## REGULAR MEETING CONSERVATION COMMISSION

4:00 P.M. July 9, 2025

## Memo

SUBJ: July 9, 2025 Conservation Commission Meeting

# PORT INN AND SUITES 505 US-1, PORTSMOUTH, NH 03801 FLECTRIC VEHICLE CHARGING STATION

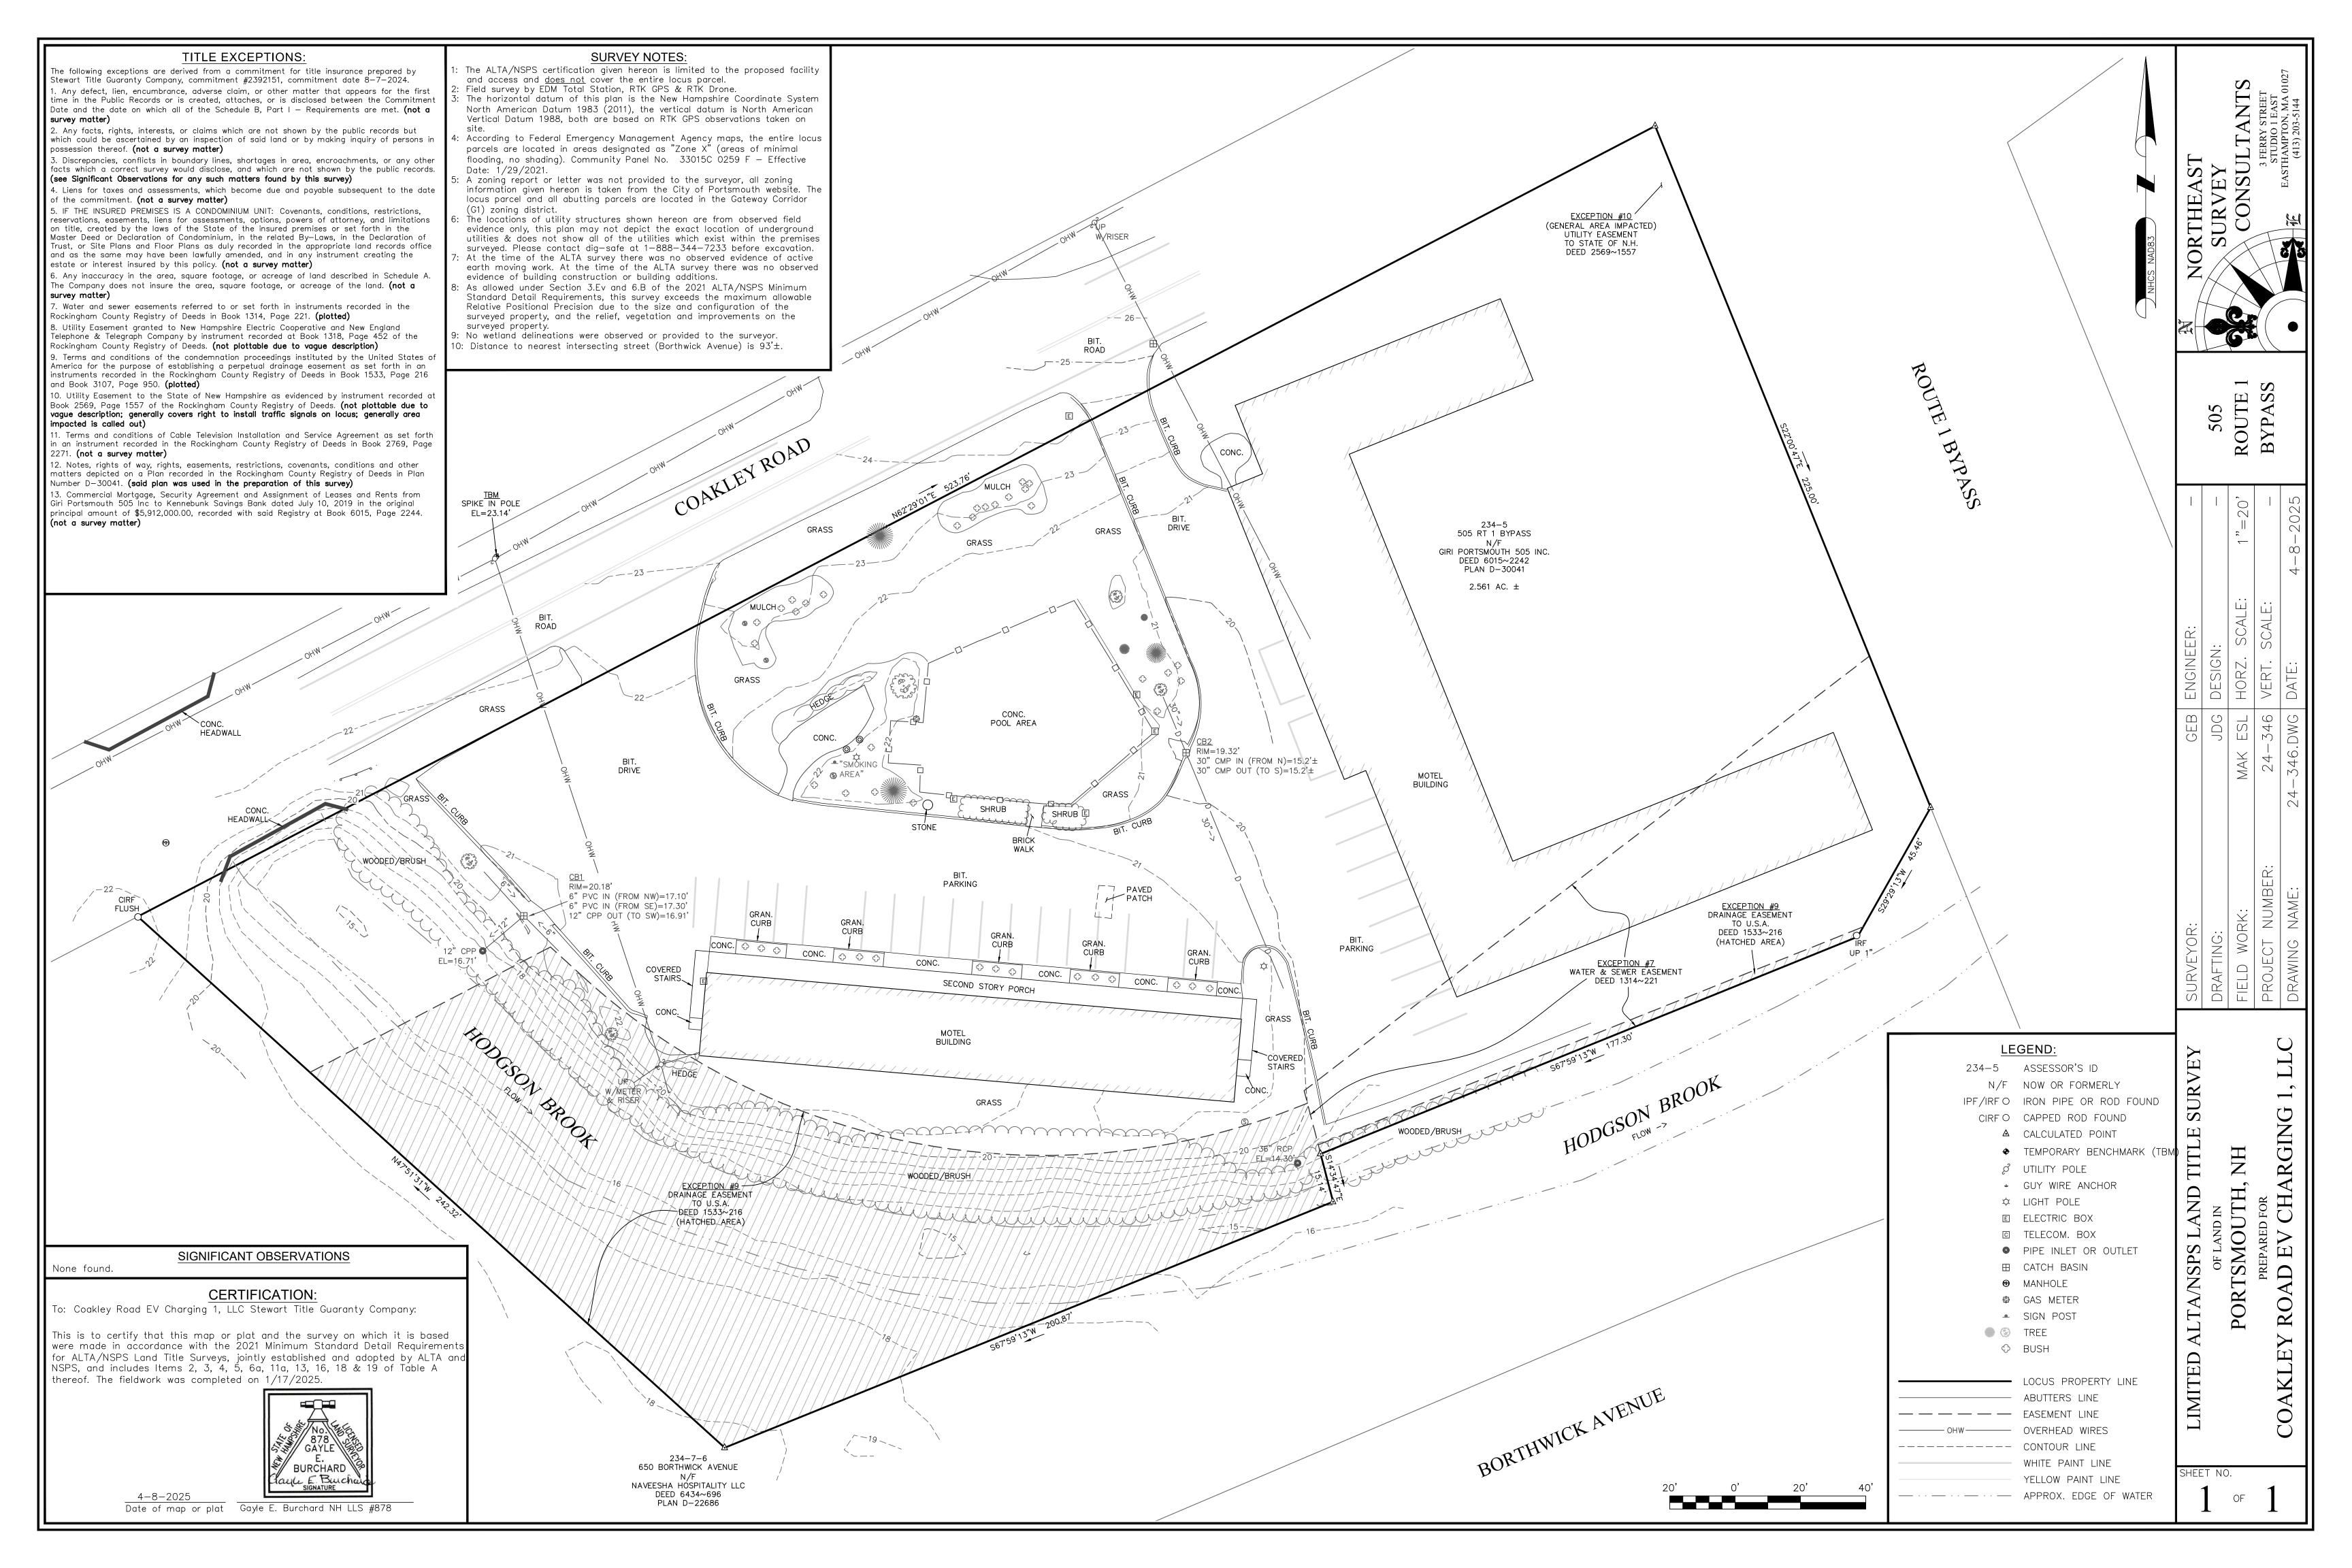
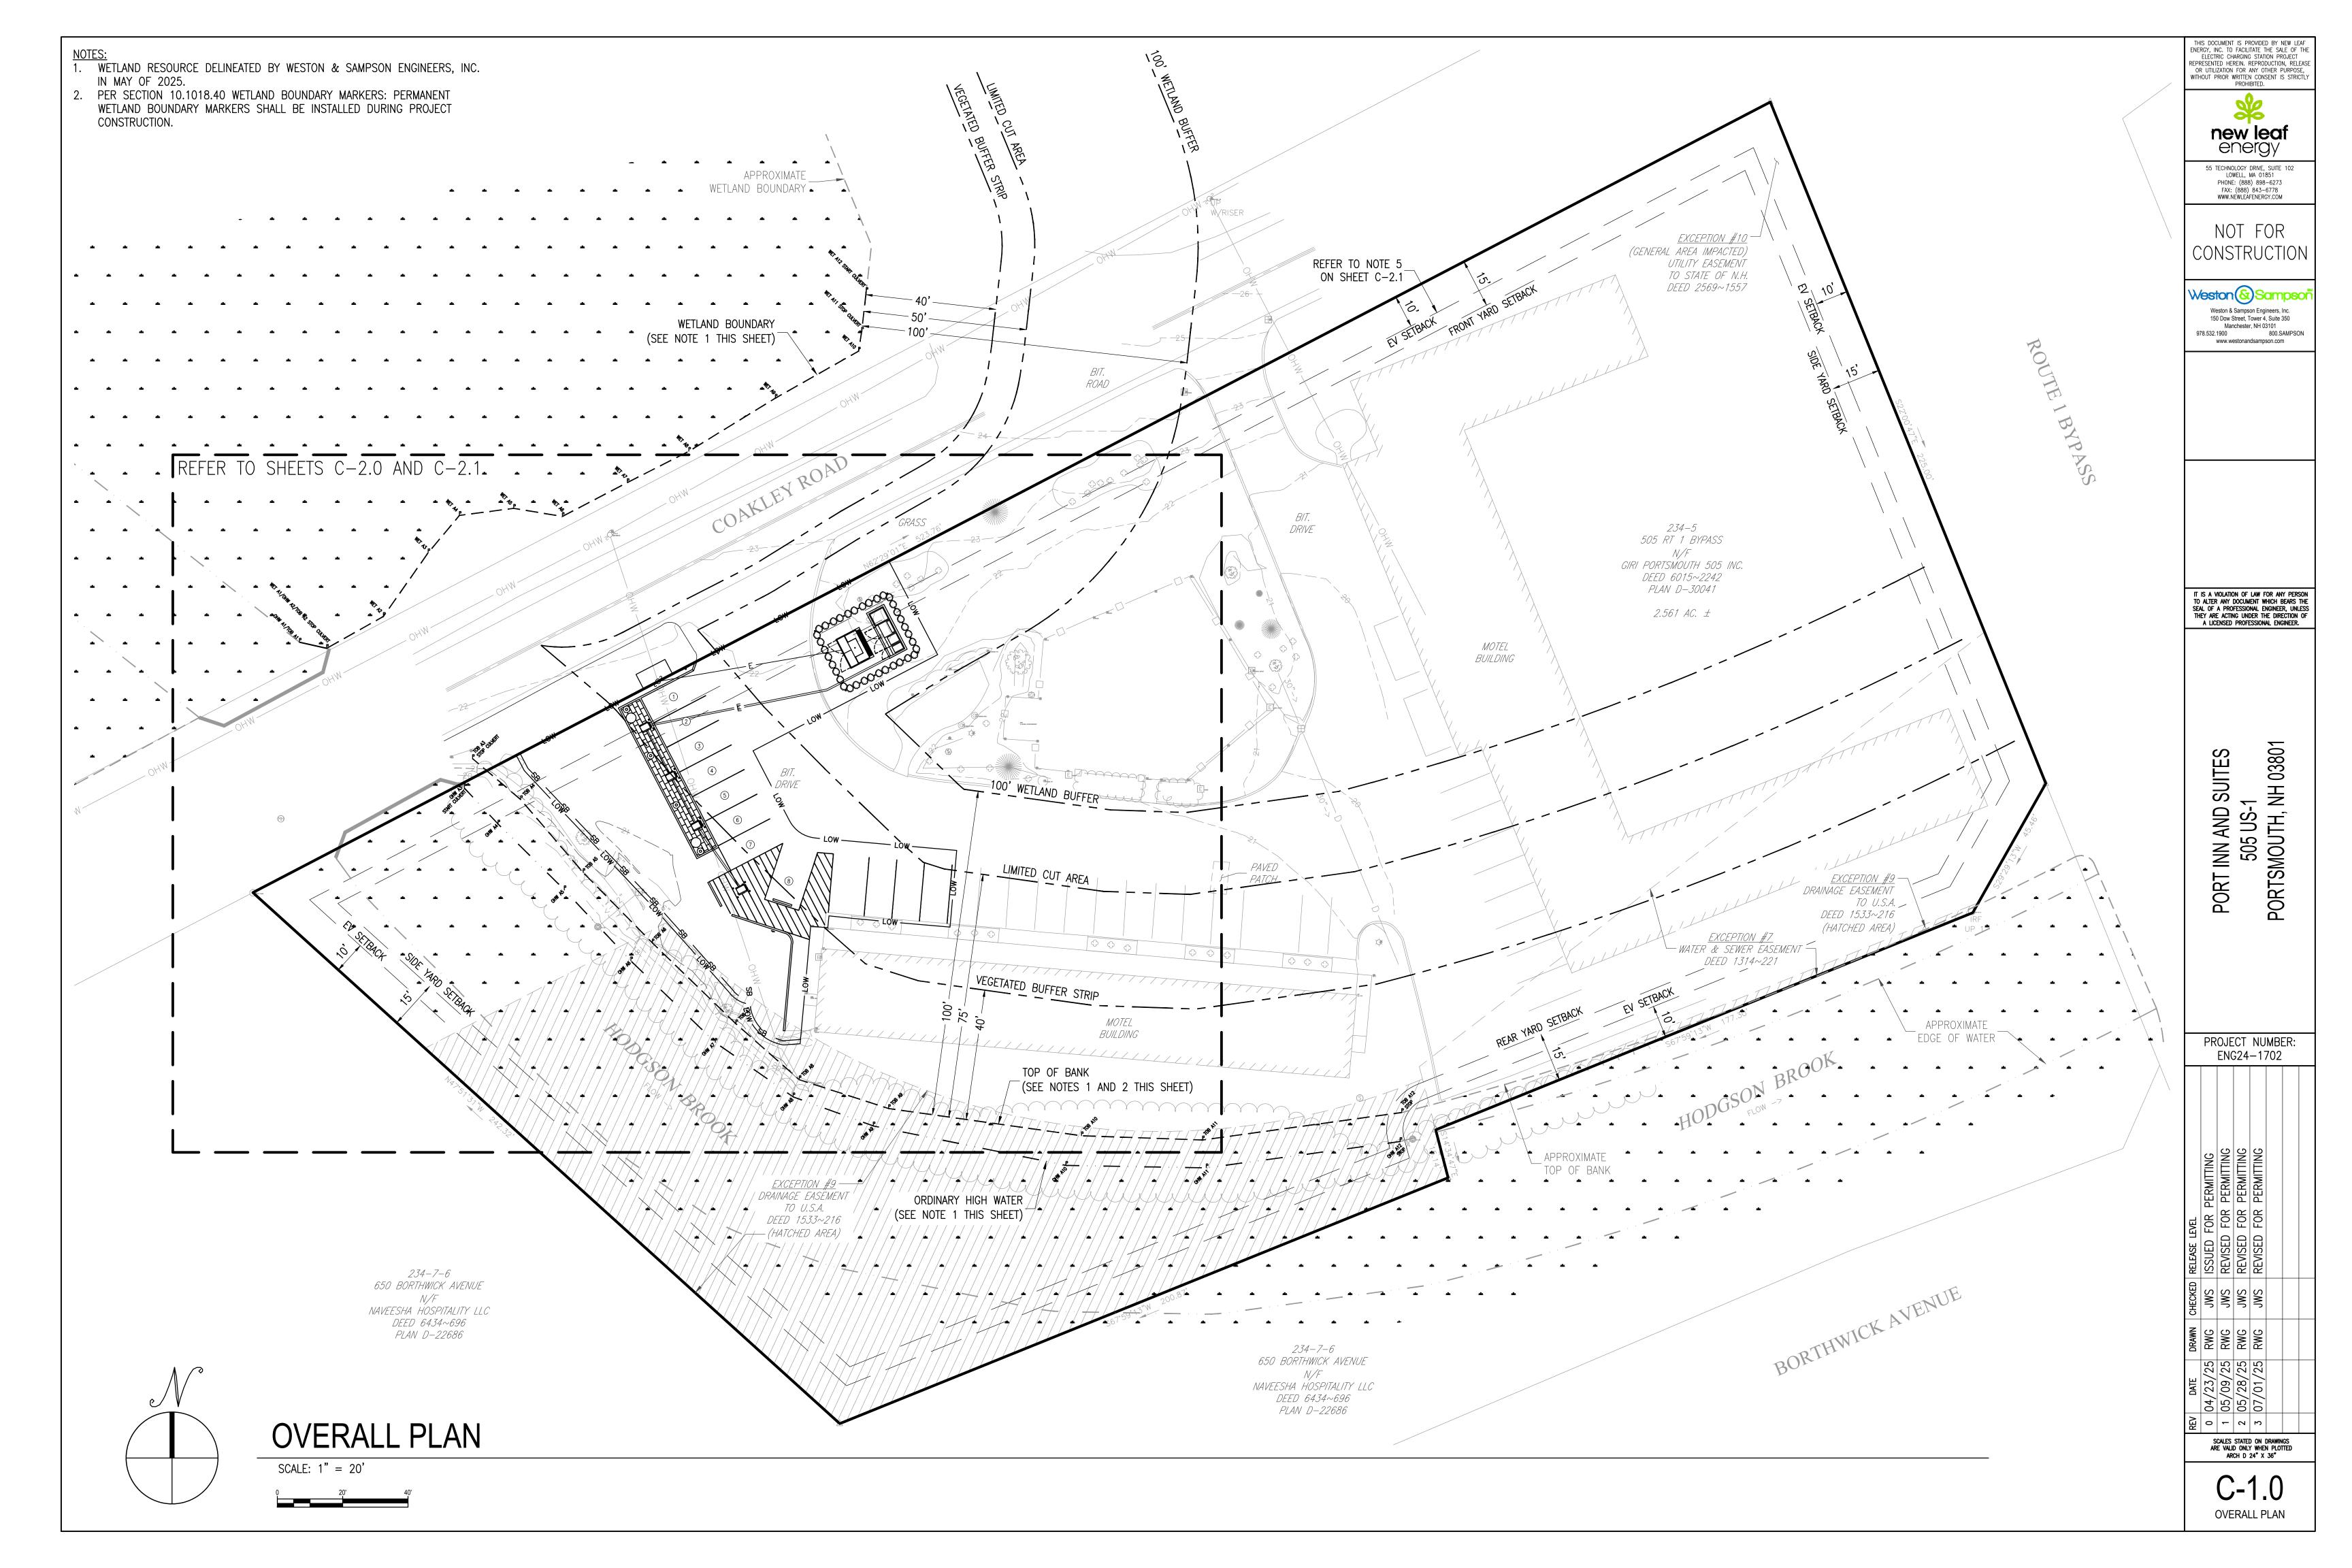
This project is for the installation of four new electric vehicle charging stations within the parking lot of the property. This would include creating and/or re-striping eight parking spaces and installing the necessary equipment and utility connections needed. This work will occur within the wetland buffer of Hodgson Brook and includes the removal of 2,135 s.f. of existing asphalt and converting to wetland buffer seeded area. It also includes 173 s.f. of permanent impacts to an existing landscape section within the buffer to install the transformer and concrete pads. In total, this project will create a net impervious of 1,962 s.f. within the 100' buffer.

The existing site is asphalt and is reasonably suited for the installation of such infrastructure.

The EV chargers have been located as far away from the wetland resource as possible while still being able to maintain the same number of parking spaces. The applicant is removing a significant amount of impervious from the vegetated buffer, planting native species and shifting the new infrastructure further from the brook.

The brook is already a heavily impacted resource and bolstering its buffer is critical to its protection. The removal of pavement between the proposed chargers and the brook will help to reclaim part of the wetland buffer. In addition to removing impervious, the applicants are also proposing to establish new plantings within the new pervious areas and maintain the intended existing drainage on the site.

This project proposes alterations with the construction of new transformers and concrete pads but plans to remove existing pavement and replant which will help offset those impacts.

The removal pavement from the 40' vegetated buffer strip and the installment of seed mix and plantings will be an improvement.

**Recommendation:** Staff recommends approval of this wetland conditional use permit to the Planning Board with the following conditions:

1. In accordance with Section 10.1018.40 of the Zoning Ordinance, applicant shall permanently install wetland boundary markers, which may be purchased through the City of Portsmouth Planning & Sustainability Department. Markers are to be placed along the 25' vegetative buffer at 50-foot intervals and must be permanently installed as a part of this after the fact permit.
